## CASE INFORMATION

CASE:	UDP-S24021
MEETING DATE:	April 23, 2024
REQUEST:	Site Plan Level III Review: Conditional Use for Building Height Exceeding 75 Feet, Alternate Design Request, and Associated Parking Reduction for 972-Unit Multifamily-Residential Development in the Uptown Area
APPLICANT:	Cypress Development, LLC.
AGENT:	Stephanie Toothaker, Esq.
PROJECT NAME:	Cypress Development
PROPERTY ADDRESS:	150 NW 68th Street
ZONING DISTRICT:	Residential Multifamily Mid Rise/Medium High Density District (RMM-25)
LAND USE:	Employment Center
COMMISSION DISTRICT:	1 - John Herbst
NEIGHBORHOOD ASSOCIATION:	N/A
CASE PLANNER:	Jim Hetzel

**BUILDING - Case Number: UDP-S24021**

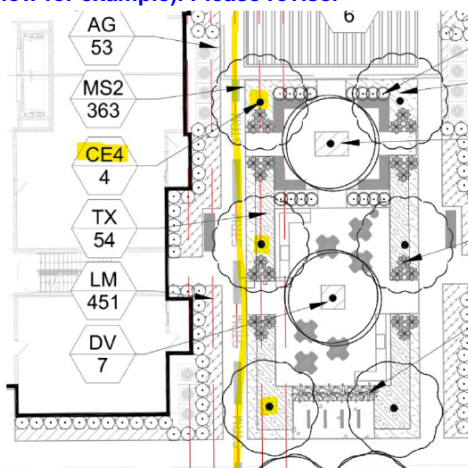
**COFL Comment:** Not accepted. Plant schedule specifications require revision to comply with this requirement. Several instances of conflicting specification remarks on tree height and trunk height for proposed trees within site triangles (see below). Please revise.

SPREAD: 7' | 6' SINGLE STRAIGHT TRUNK | 8'  
 CLEAR TRUNK

**Applicant REV 2 Response:** Please see revised planting plans and planting schedule.

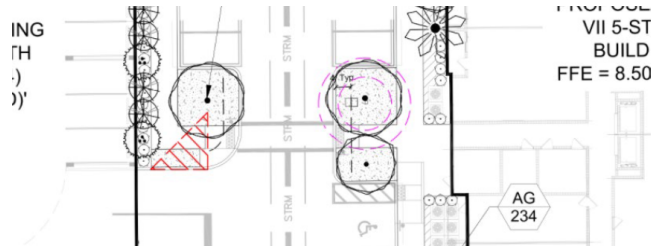
**COFL Comment:** Corrections required. See comment response below for example of proposed tree-light fixture conflict that requires revision.

**Applicant REV 2 Response:** Noted. Please refer to revised plans for the relocation of removal of the trees in conflict with light fixtures.

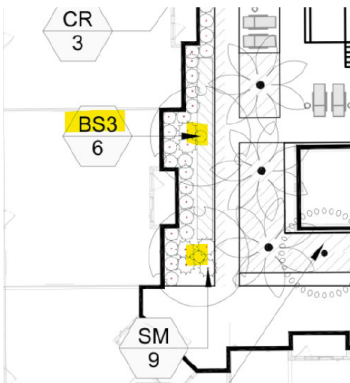
13. Shade trees must be located a minimum of fifteen feet away from structures. Section 47-21.9. F.1. Please illustrate on plans.

**COFL Comment:** Not accepted. See below for one of many examples of proposed shade tree conflict with proposed structure. Please revise.

**Applicant REV 2 Response:** Noted. Per our call with the reviewer we have adjusting the planting selection abutting structures to be small trees and palms maximum.

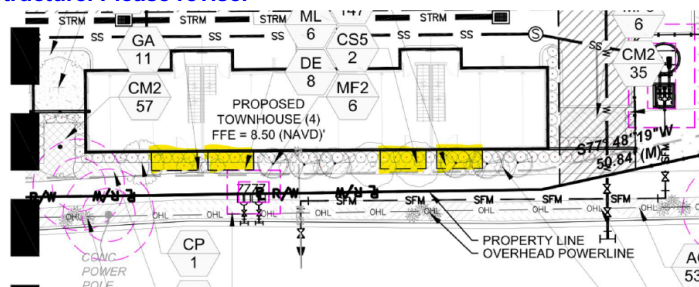
14. Small trees and palms must be located a minimum of seven and one-half feet away from structures. Palms may be planted closer to each other to form clusters. Please illustrate on plans.

**COFL Comment:** Not accepted. See below for one of many examples of proposed small tree conflict with proposed structure. Please revise.

**Applicant REV 2 Response:** Per our conversation with reviewer, we are able to plant small canopy trees and palms abutting the structure and we have revised the planting plan as such. Please refer to updated planting plans.

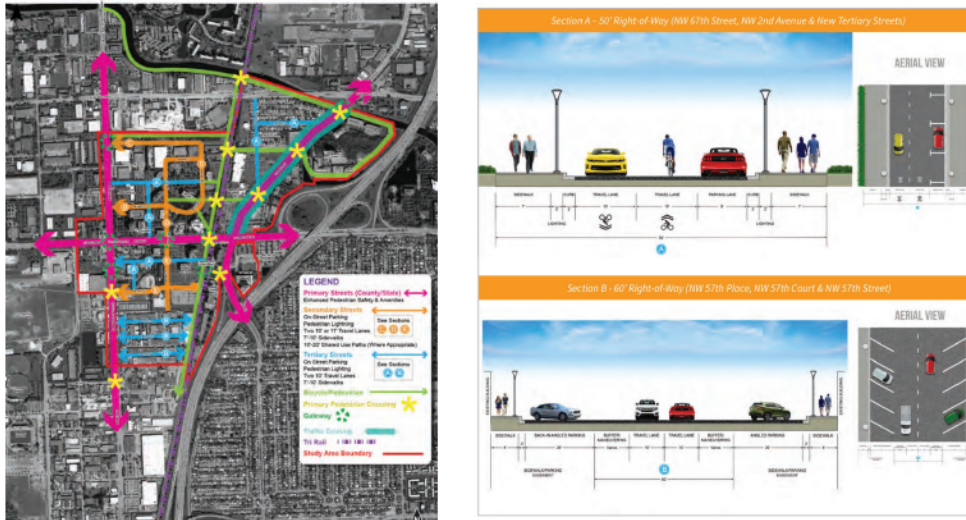
- UMP, Master Plan Framework 4.6, mobility concept depicts two tertiary streets to create a street grid for this area that would include street cross section for sidewalks, travel lanes, landscape, and bicycle/pedestrian pathways. Proposed project does not reflect this layout. See image below.

**Applicant REV 2 Response:** Tertiary streets are defined as “...internal connectors identified primarily for service and site access to individual development sites” (emphasis added, see ULDR Sec. 47-37B.6.D). The previous east-west internal private street that was part of the site layout of the now demolished mobile home park and was envisioned as remaining on the development site per the Uptown Master Plan Mobility Concept has been reconfigured in Applicant’s proposed site plan. The new site layout, which better serves the functional needs of the proposed development, no longer maintains the east-west connection, but the development still adheres to the intent of the Uptown Master Plan by preserving a north-south internal street that is consistent with the objectives of improving connectivity and mobility with pedestrian-friendly infrastructure that connects to a new proposed 7’ wide sidewalk on NW 66<sup>th</sup> Street. Further, as confirmed by City staff at the October 22, 2024 DRC Meeting for the Plat (UDP-P24006), tertiary streets on the development site are not required to be dedicated in fee simple or easement by plat or other instrument. Therefore, Applicant is requesting an alternative design deviation from the street cross section design to allow for flexibility in the design while still meeting the intent of connectivity and site access.

Original Submittal:

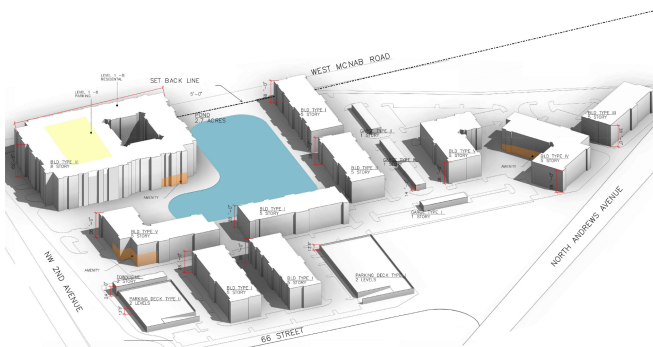
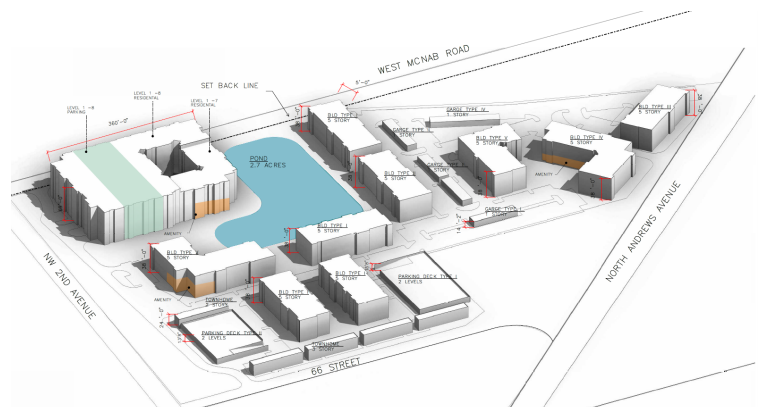
- Q. The overall intent of the Uptown Urban Village Northeast District (UUV-NE) is to contain a mixture of residential and non-residential uses with more intense development pattern that accommodates a variety of retail, restaurant and entertainment uses compatible with residential uses. As proposed, the proposed site plan does not meet the design intent for Uptown. The site layout and design is reflective of a suburban garden apartment development with multiple buildings separated by expansive surface parking and lacks several key design requirements for Uptown. Applicant must demonstrate compliance with the Uptown regulations and master plan vision this includes the following: (1) site design and layout that provide for building presence and ground floor activity fronting primary and secondary streets, (2) site layout reflective of perhaps a grid pattern, (3) streetscape design that includes wide sidewalks and multimodal elements, and (4) architectural finishes of higher quality materials.

**Applicant REV 1 Response:** In response to staff comments, the site plan has been modified to align further with the Uptown vision. Some key modifications include: (1) Site Design and Layout: The original row of surface parking along NW 66<sup>th</sup> Street has been replaced with four 4-unit (16 units total), 3-story townhome buildings. This change enhances the building presence and activates the NW 66<sup>th</sup> Street (Secondary Street) frontage, consistent with the treatment along W. McNab Road and N. Andrews Avenue (Primary Streets) with the other residential building types. (2) While the Project supports the intensity encouraged by the UUV-NE zoning district in a horizontal fashion, the varying low- to mid-rise residential building types are well-suited to the mixed-income nature of the Project. (3) Streetscape Design: Additional internal sidewalk connections and crosswalks have been added and sidewalks widened to between 5 and 9 feet, improving connectivity to amenitized pocket park areas (shaded in orange above, totaling 109,455 square feet) and to the exterior sidewalks. The exterior sidewalks include a minimum 7-foot wide sidewalk on NW 66<sup>th</sup> Street, a 10-foot (8-foot clear width) sidewalk along N. Andrews Avenue, and an existing 5-foot wide sidewalk on W. McNab Road. Additional multimodal elements include the incorporation of bike racks and storage facilities throughout the Project to further encourage use of alternate modes of transportation and reduce car dependency. (4) Architectural Finishes: The Project features high-quality architectural finishes, including storefront glazing and sections of brick, stone, or wood paneling on the first and second levels, to enhance the pedestrian experience.

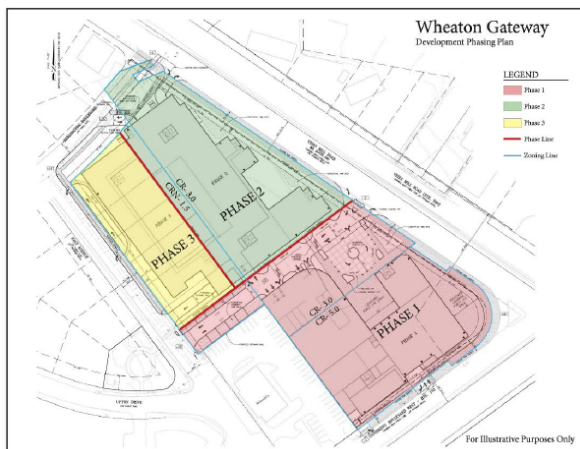
**CITY COMMENT:** Comment not addressed. Please refer to the application site plan specifications for the specific renderings needed for Site Plan Level III applications and provide accordingly.

**Applicant REV 2 Response:** Acknowledged. The overall renderings presented do not yet reflect the updated townhomes and site plan configuration; however, they still provide a general sense of the site layout. The zoomed-in renderings do accurately represent the building designs. Please refer to Sheets RE-1 through RE-5 for more details. Current renderings to be provided in REV 3 submittal.
